Department of Transportation

MEMORANDUM

SUBJECT: ZC Case No. 23-08A –Wesley Theological Seminary Campus Plan Further Processing

Figure 4 | Existing Pedestrian Facilities

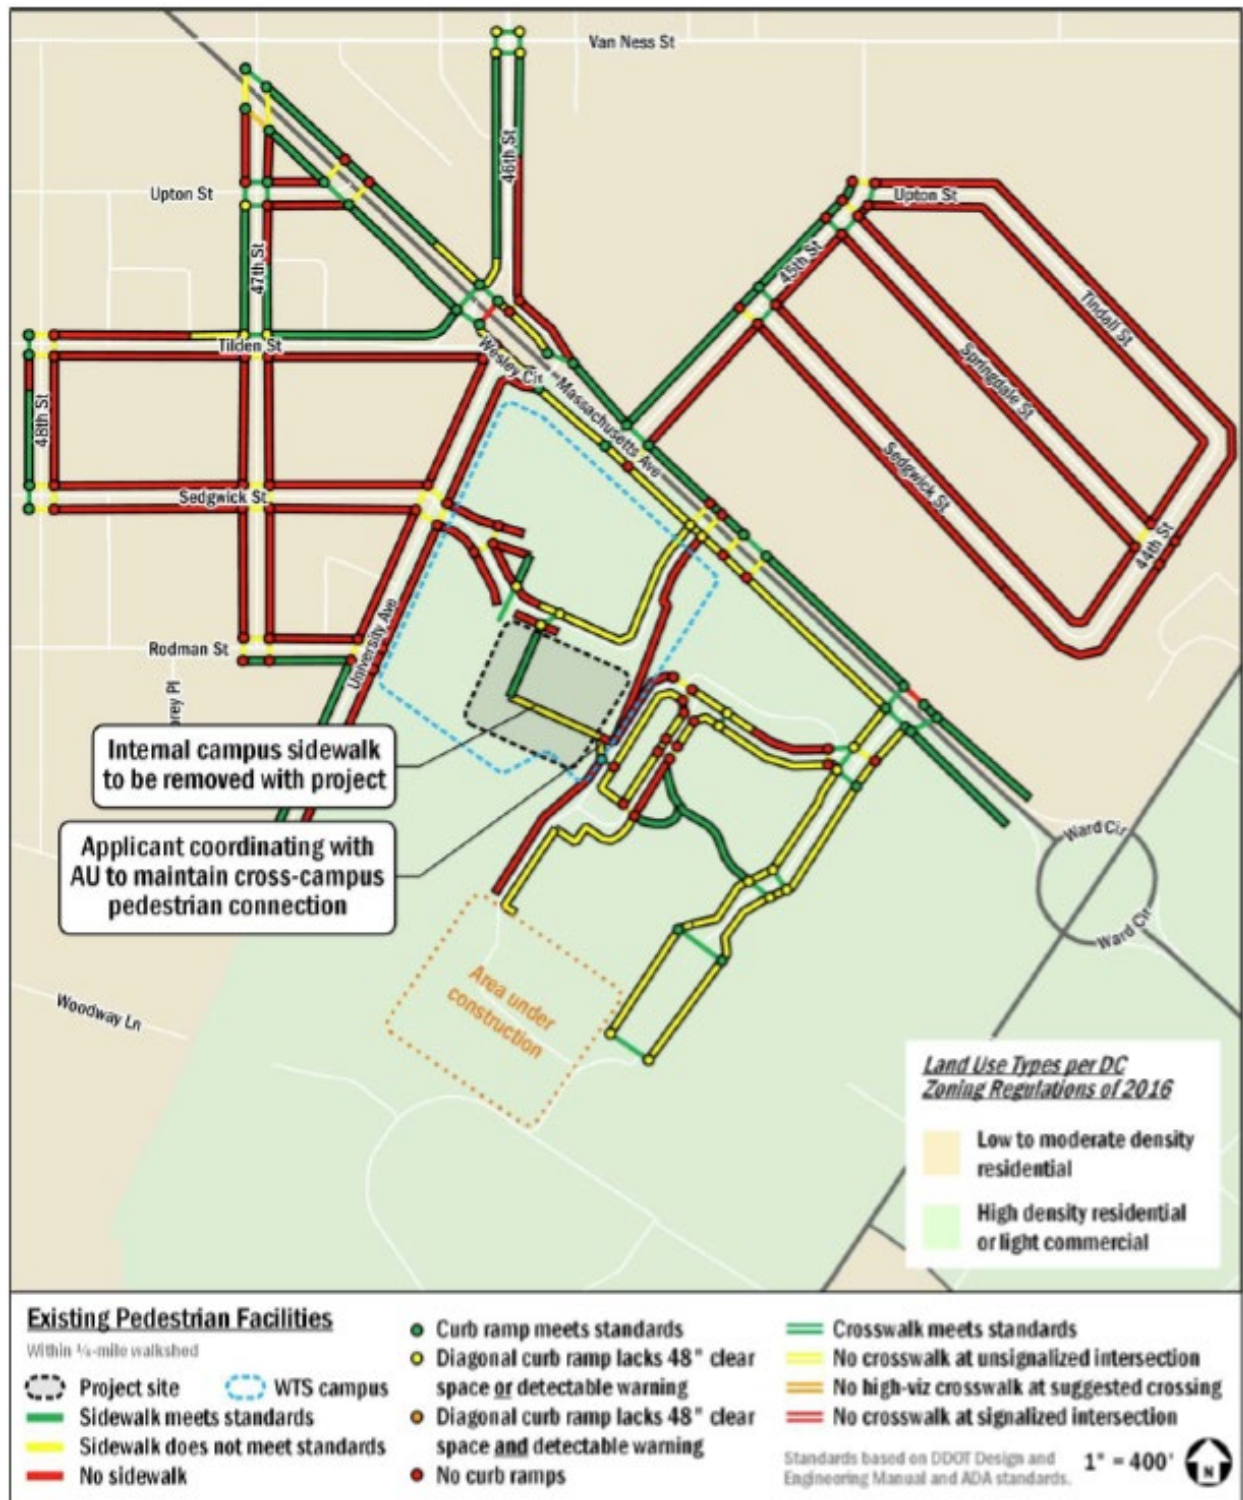
The Applicant's inventory of the pedestrian infrastructure in the vicinity of the campus, as shown in Figure 4, below, demonstrates that there are significant missing connections in the study area, particularly along University Avenue. To help offset the projected increase in traffic volumes and to encourage non-automotive travel to and from the site, in the TDM Plan for the approved WTS Campus Plan, the Applicant has committed to installing the missing sidewalk along University Avenue, the missing ADA facilities with a leadwalk into campus, and wayfinding signage on-site for residents seeking to walk to AU campus.

Figure 5 | Existing, Planned, and Proposed Bicycle Facilities

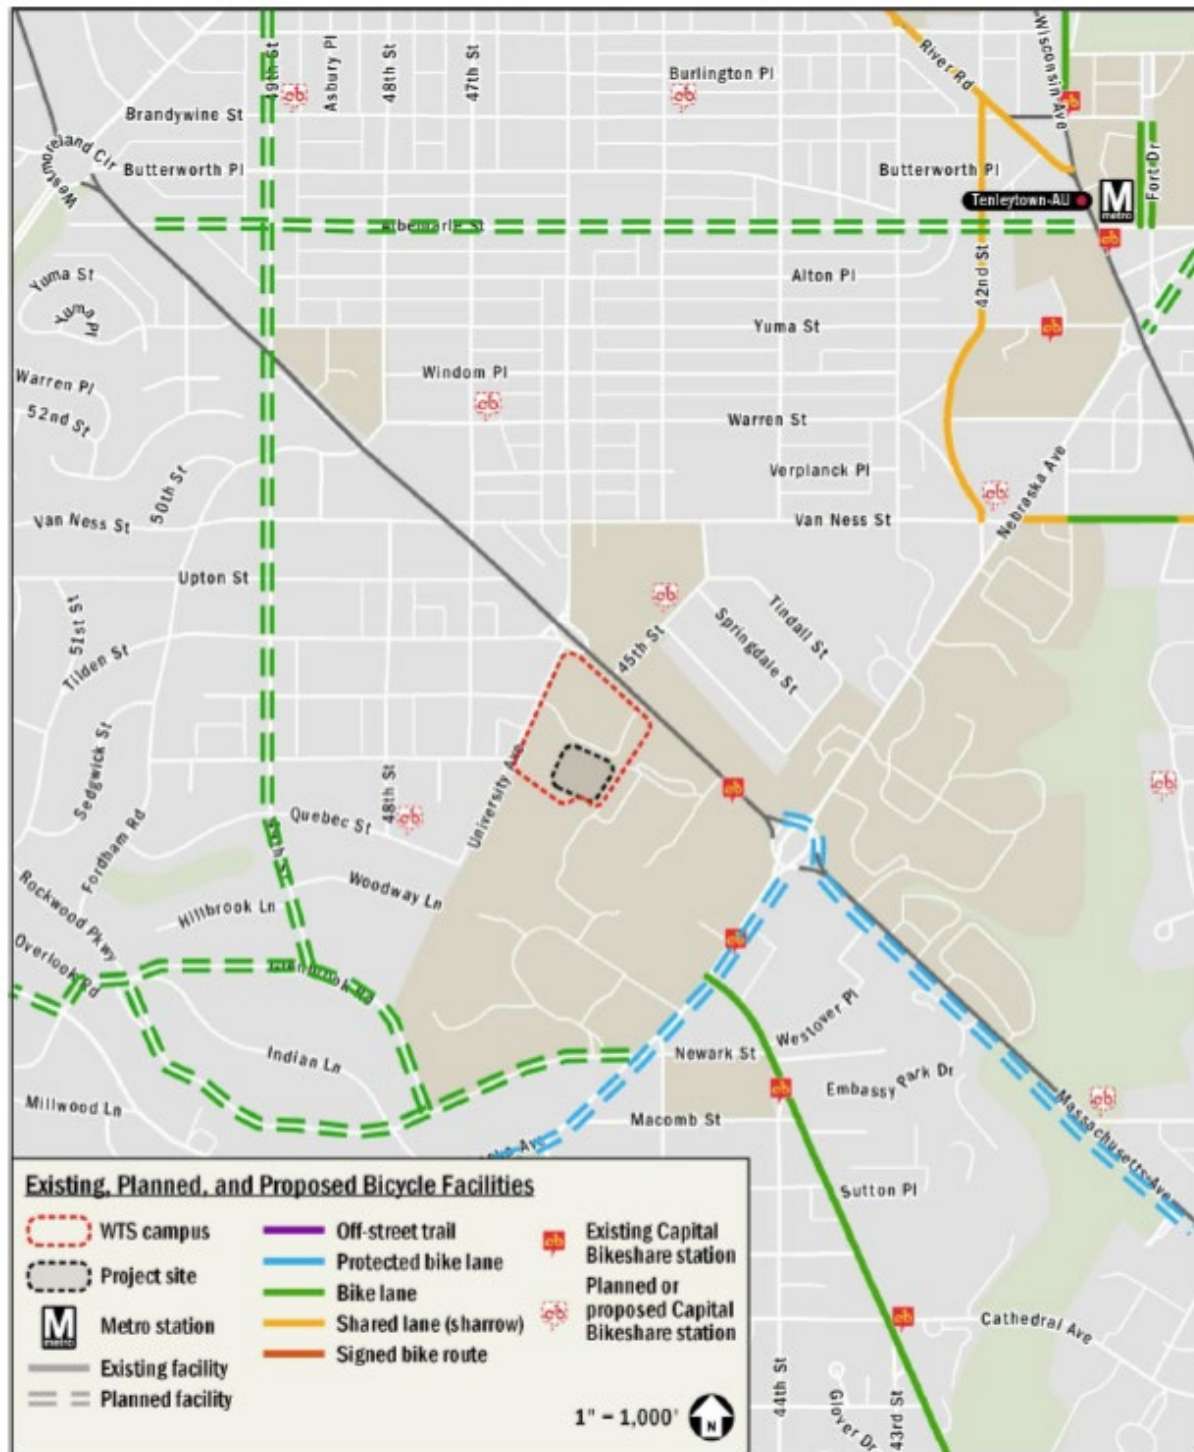
As shown in Figure 5, below, there is only one bicycle lane and no trails within ½ mile of the site; however, there are planned facilities in the future. There is one (1) 19-dock Capital Bikeshare station located approximately two (2) blocks from campus. In the TDM Plan for the approved WTS Campus Plan, the Applicant has committed to fund and install a 19-dock Capital Bikeshare (CaBi) station with 12 bikes on the campus, or at a location to be selected by DDOT, fund one-year of maintenance and operations costs, and fund and install one scooter corral near the library.

Figure 7 | Curbside Designations

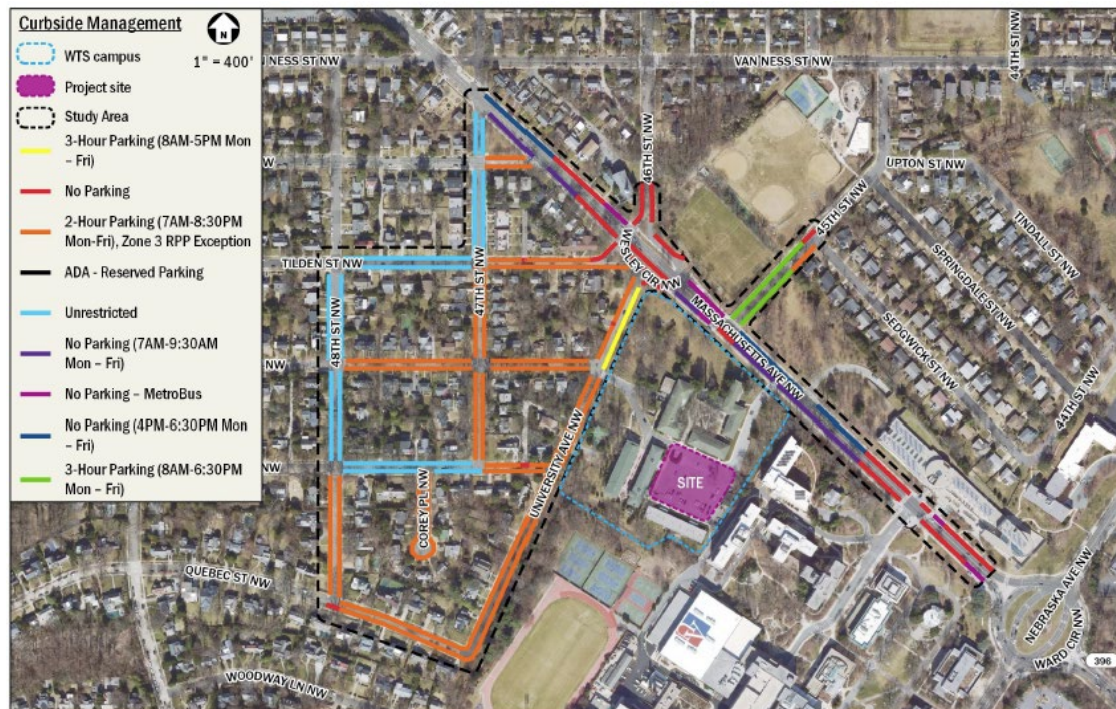
The Applicant has not proposed any changes to the curbside designations with this project. DDOT is generally supportive of this concept; however, if any changes are proposed, a detailed curbside and signage plan must be submitted during public space permitting for review and approval by CMD. At that time, the plan may be refined by CMD, and the exact signage placards would be determined. If multi-space meters are required by CMD, these would be at the Applicant's expense.
